GRAND AVENUE BRIDGE

Environmental Assessment

## **Appendix D: Agency Coordination**

## Historic Preservation — Section 106

Figure 1: Build Alternative Impacts

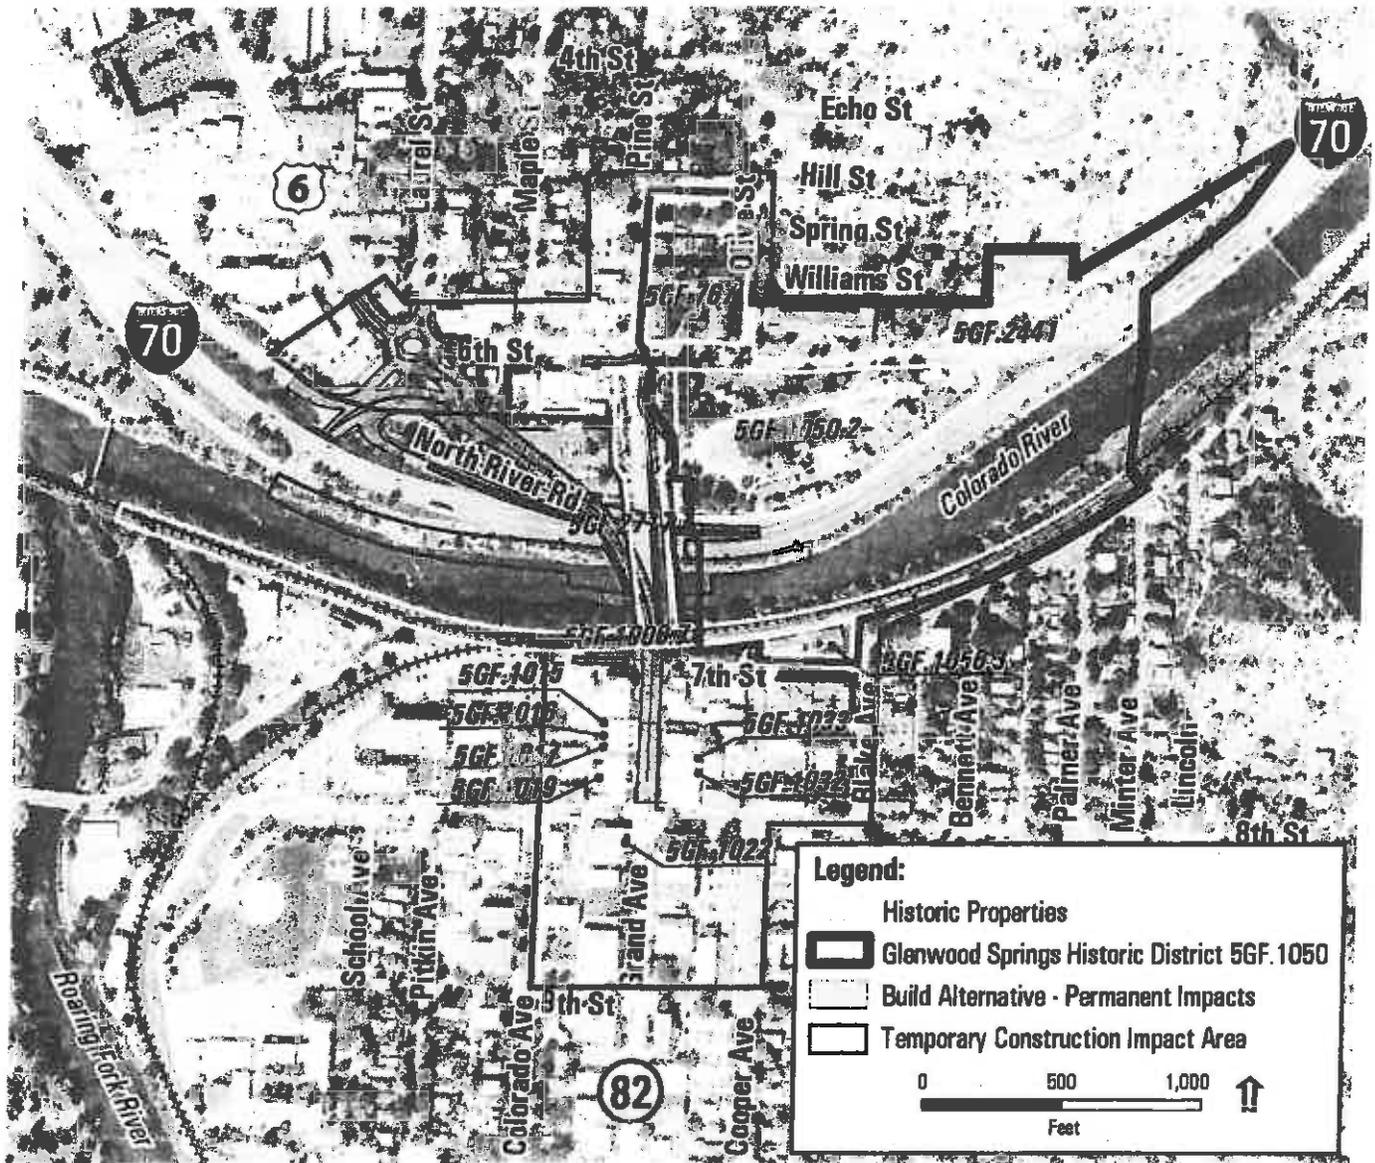
6. Figure 1, page 9 – please identify the red border in the legend as the APE.
7. Page 7- CDOT determined that the temporary and indirect impacts of the bridge project will not affect the Citizens National Bank building, a property that is listed on the National Register of Historic Places. This is a minor point but CDOT's determination was "no historic properties affected". Should the determination be "no adverse effect" since this is a historic property?

**Figure 5: Proposed Scissor Ramp on East Side of Bridge**

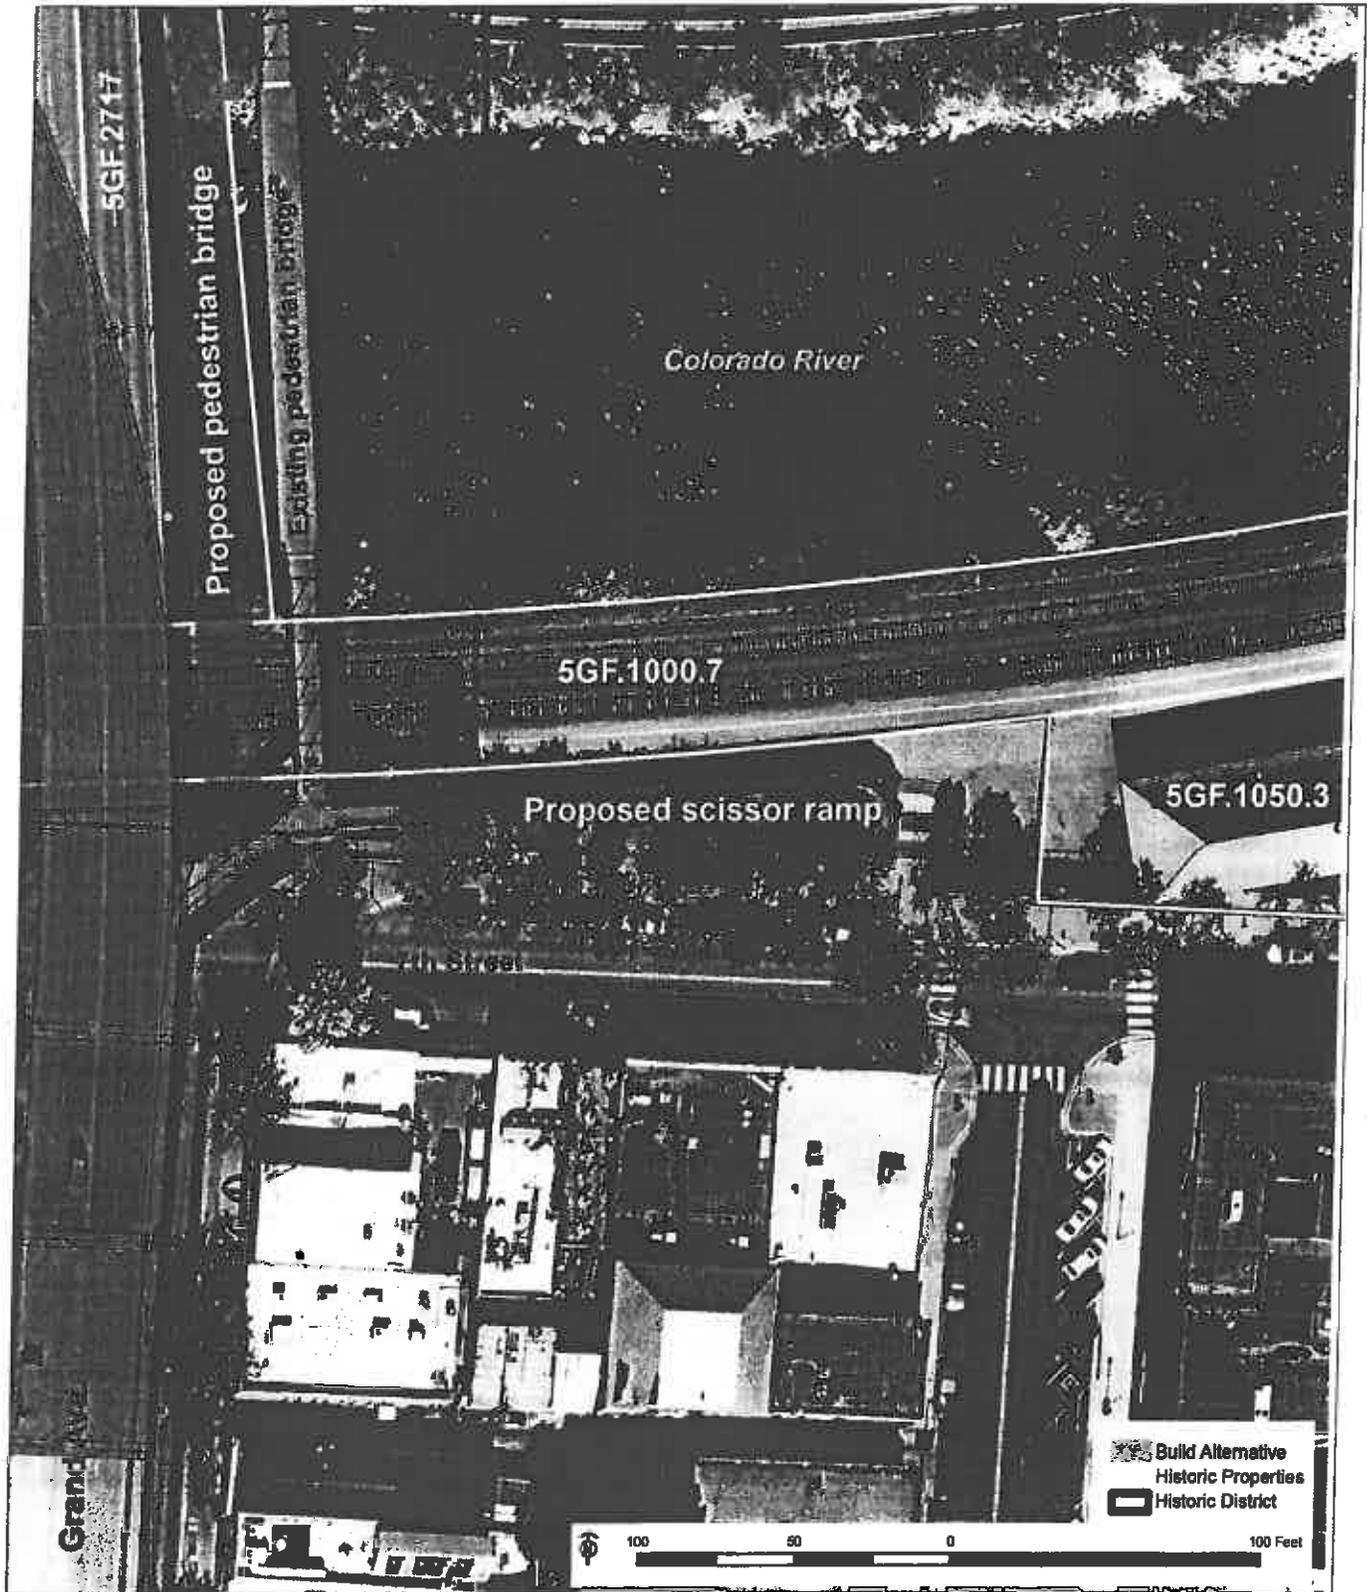
impact if an elevator was constructed. Additionally, should CDOT note the proximity of the scissor ramp's east wall to the west side of the station, and note the height of both the ramp and elevator shaft. Finally, should CDOT note the elevator location in figure 5, page 13?

Layout of dual elevators and stairway pedestrian bridge connection. Note: A preliminary level of design is shown and is subject to modification. Source: AMEC

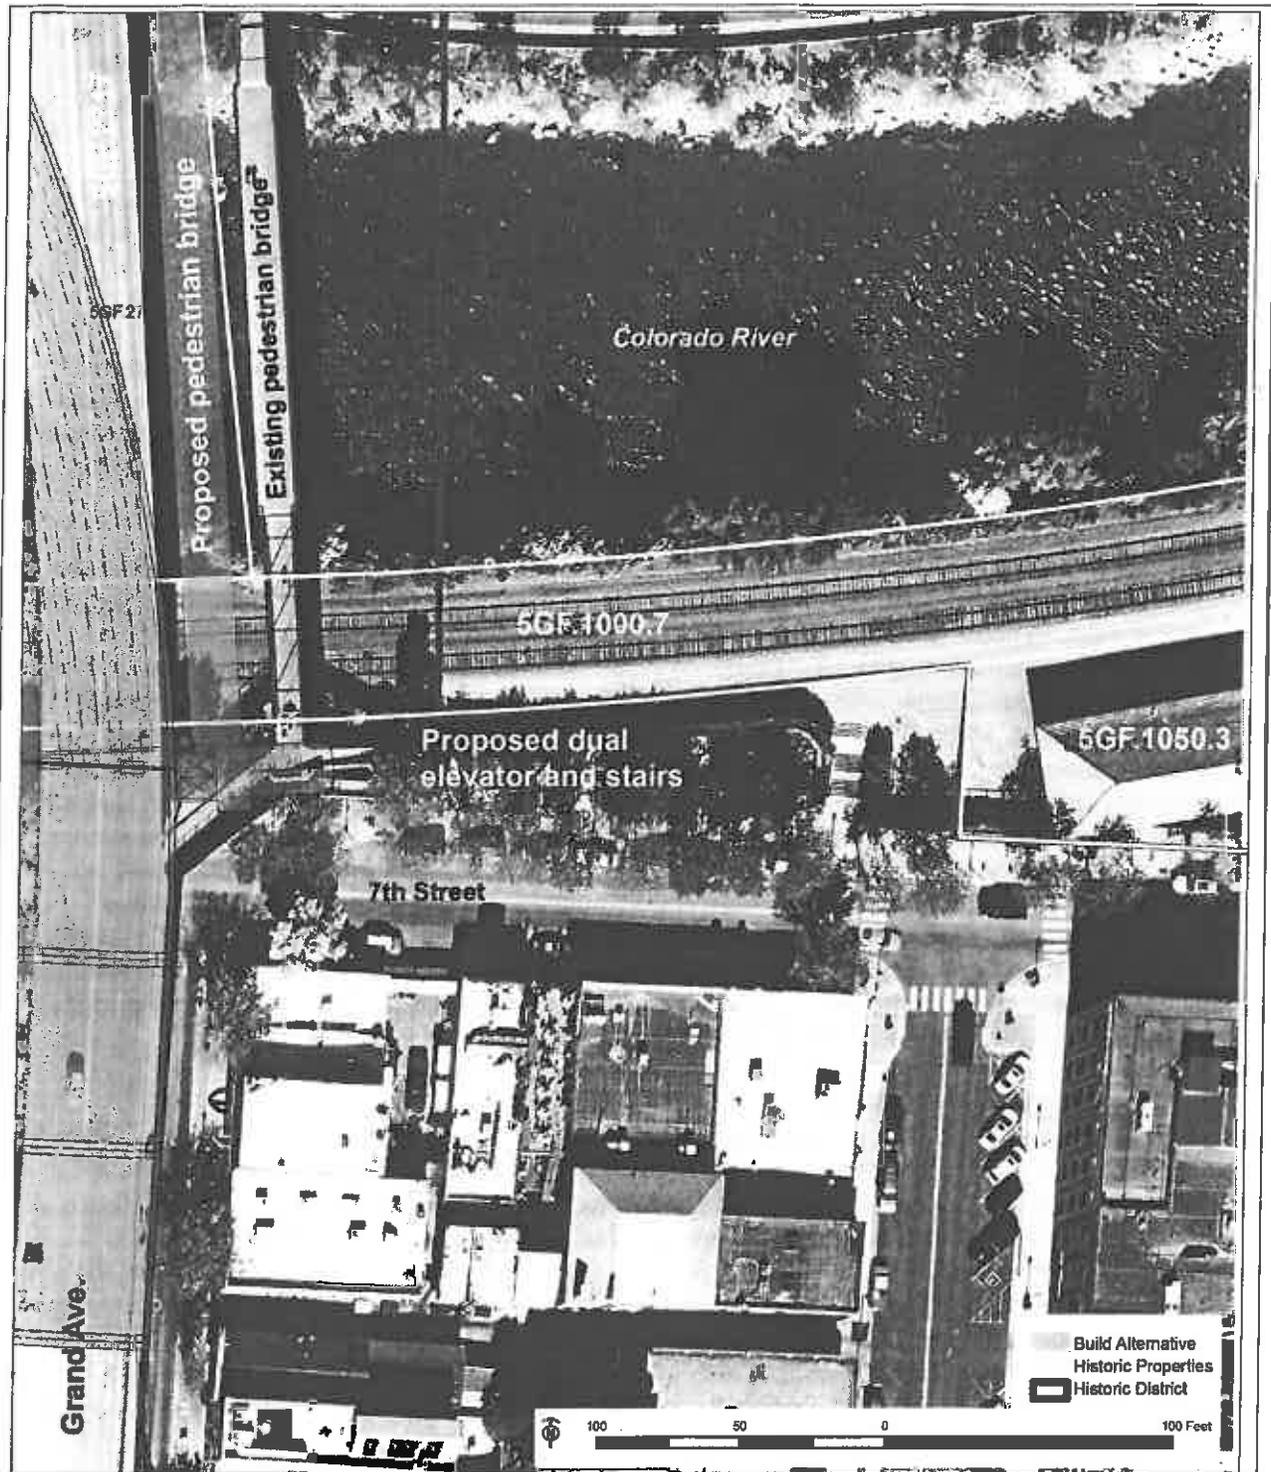
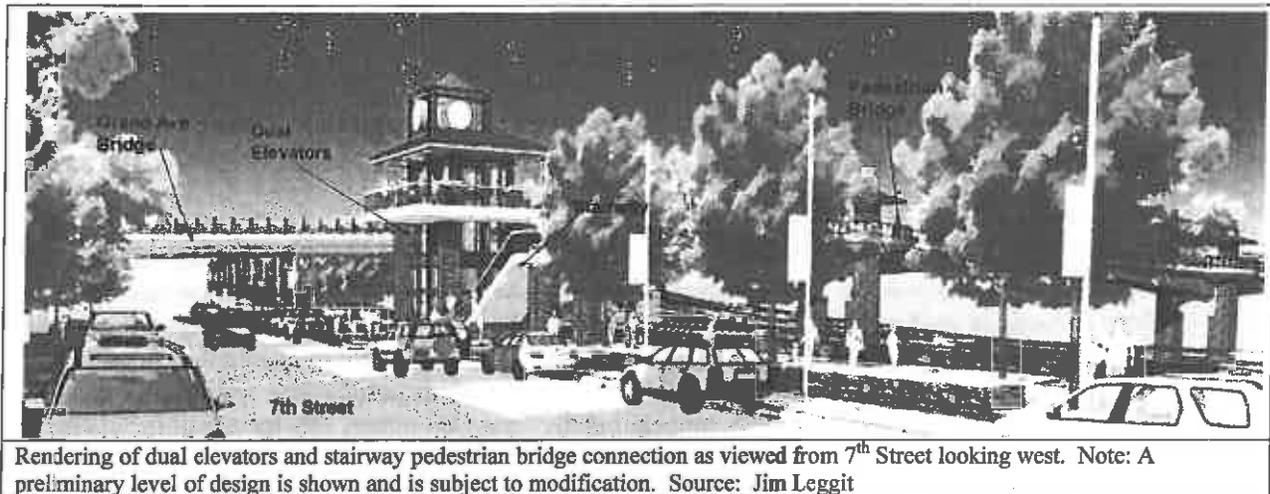
**Denver & Rio Grande Railroad Station (5GF1050.3):** When we consulted in August 2013, elevator and/or scissor ramp configurations were being considered for the new pedestrian bridge access. Since that time, the design has been modified; a scissor ramp is no longer being considered and dual elevators are now proposed. The elevators would be located at the south end of the pedestrian bridge, with the stairway located on the east side of the elevator bank.

Depending on the roof design, the elevator height would extend approximately 15 to 20 feet above the pedestrian bridge deck. The scissor ramp would have been located approximately 68 feet from the train station, whereas the dual elevators/stairway would be located approximately 250 feet from the train station. This increased distance results in reduced visual changes from the pedestrian bridge access to the train station. The dual elevators/stairway are also anticipated to result in minimal visual changes to buildings and viewers along 7<sup>th</sup> Street. The aerial map below shows the layout of the elevators and stairway in relation to 7<sup>th</sup> Street and the train station. The rendering on the page following shows the elevators and stairway as viewed from 7<sup>th</sup> Street looking west and also depicts a clock tower design for the elevator bank that is currently being considered. However, design of the elevator bank and stairway will continue to be refined during the final design process in coordination your office, the consulting parties and the City. The dual elevator will be visible from the railroad station and will constitute a change to the setting of the area near the south end of the proposed new highway and pedestrian bridges, but the visual change is minimal in the area of the railroad station and will not alter the qualities that make that property significant. For these reasons, CDOT has determined that the dual elevators at the proposed pedestrian bridge will result in *no adverse effect* to 5GF1050.3.

**Figure 1: Proposed Dual Elevator and Stairs**

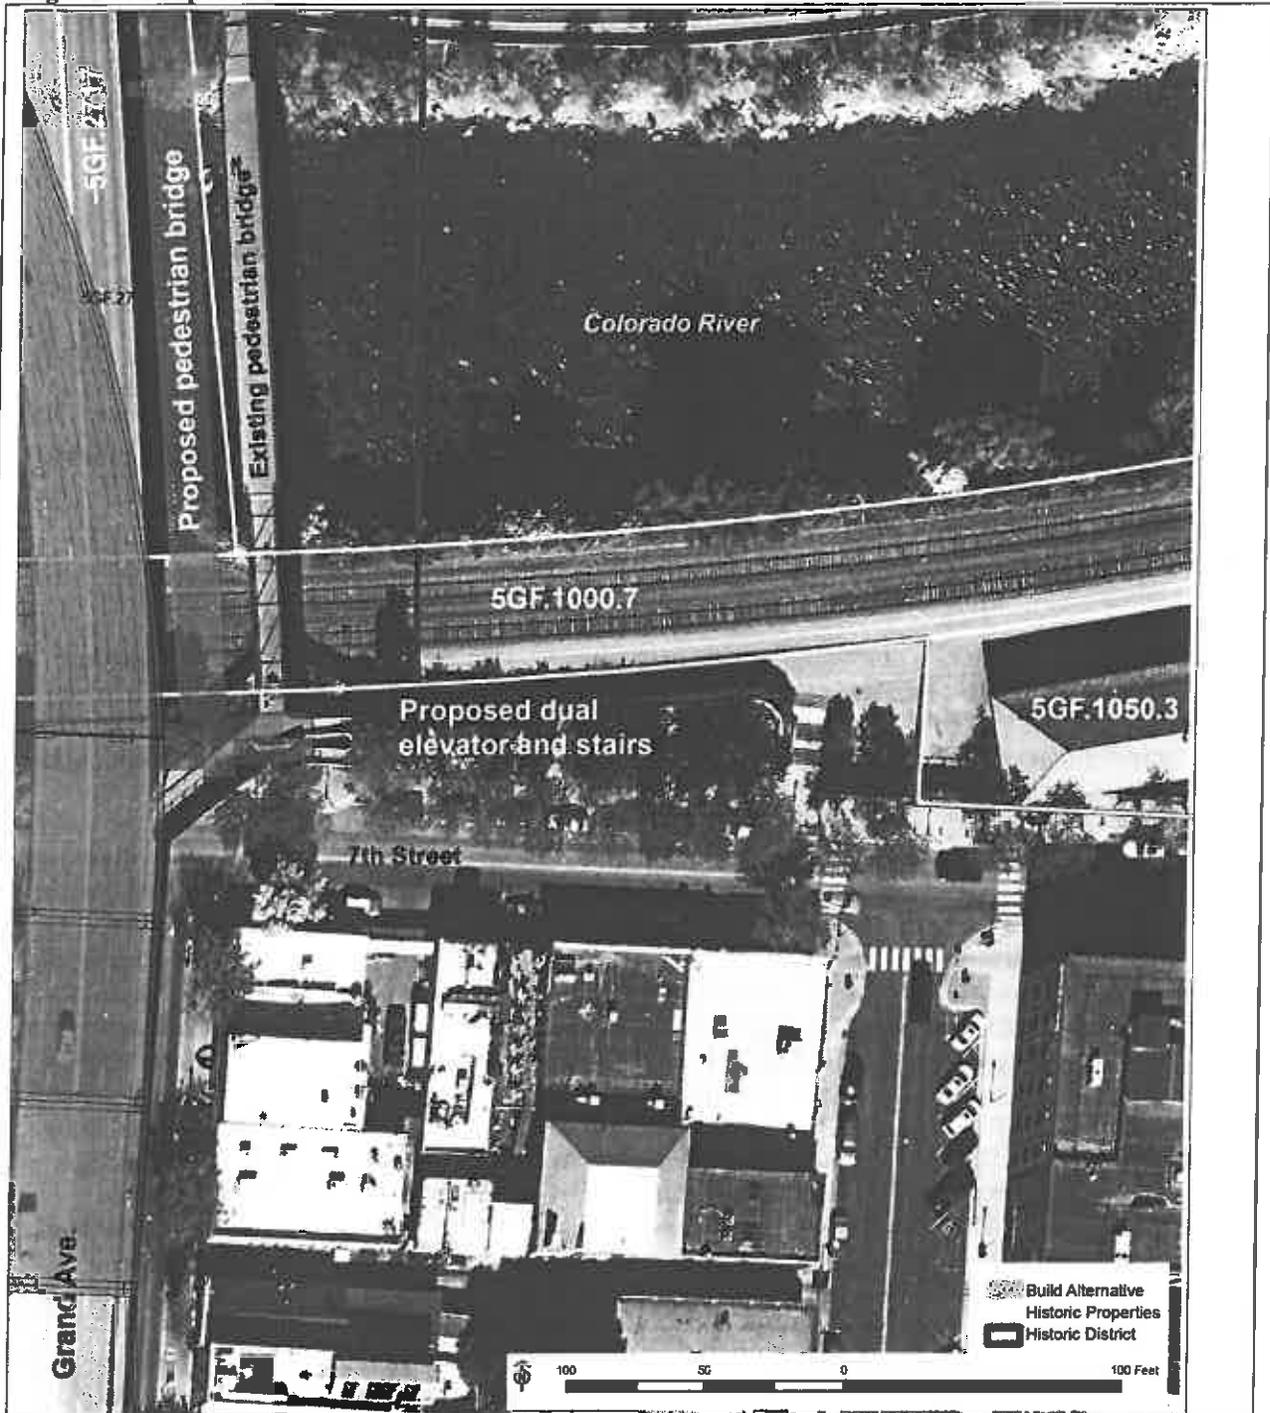
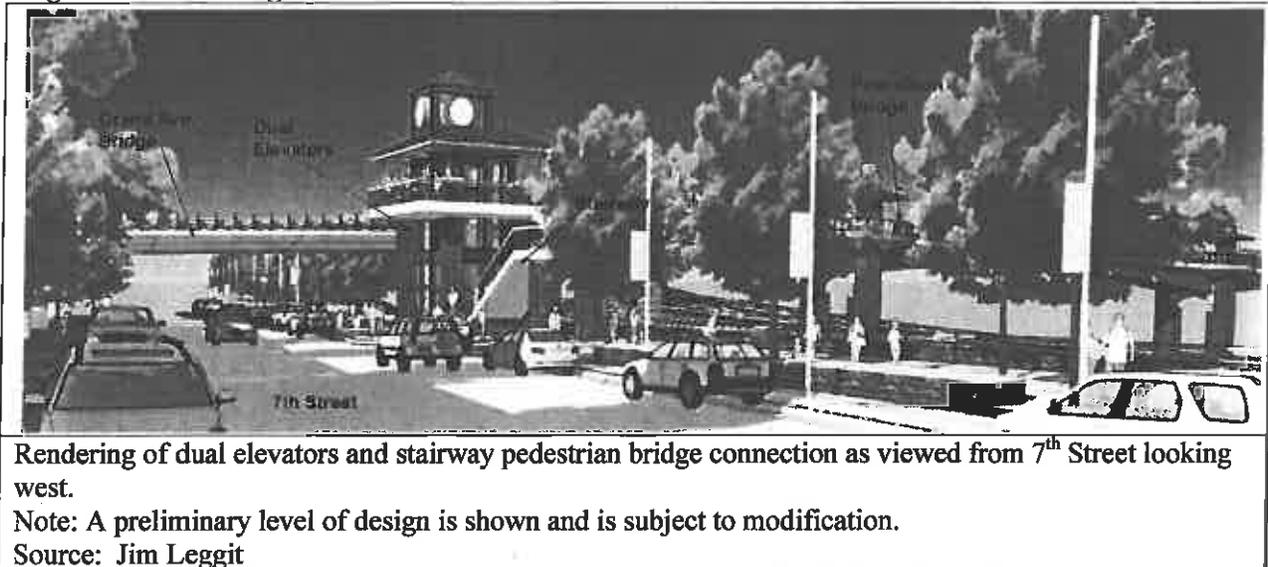
**Response to GSHPC Comment #3:** You requested more details regarding the visual effect of the scissor ramp on historic properties. Elevator and/or scissor ramp configurations were being considered for pedestrian bridge access at the time information was provided to you in August 2013. Since that time, the design has been modified and dual elevators are now proposed. The dual elevators would be located at the south end of the pedestrian bridge, with the stairway located on the east side of the elevator bank as noted in Figure 1 below. The elevator height would extend approximately 15 to 20 feet above the pedestrian bridge deck, depending on the roof design. The dual elevators/stairway would be located approximately 250 feet from the train station. This increased distance results in reduced views of the pedestrian bridge access from the train station, and is anticipated to result in minimal visual changes toward the train station. In addition, the dual elevators/stairway is anticipated to result in minimal visual changes to buildings along 7<sup>th</sup> Street and to views from 7<sup>th</sup> Street. Figure 1 shows the layout of the elevators and stairway in relation to 7<sup>th</sup> Street and the train station. Figure 2 shows the elevators and stairway as viewed from 7<sup>th</sup> Street looking west, and depicts a clock tower design for the elevator bank. However, design of the elevator bank and stairway will continue to be refined during the final design process in coordination with consulting parties and the City. The dual elevators will result in some new elements in the viewshed to and from the train station but this will not alter the qualities that make the train station significant. The project will have some temporary effects of increased dust, noise and vibration, but overall the proposed dual elevator access will not alter the characteristics of the property that qualify it for eligibility in a manner that would diminish its integrity. For these reasons, there is *no adverse effect* to the Denver & Rio Grande Railroad station (5GF1050.3).

**Response to GSHPC Comment #5:** You requested more information about the visual effect of a prominent pedestrian bridge design on the Denver & Rio Grande Railroad Station (5GF1050.3)
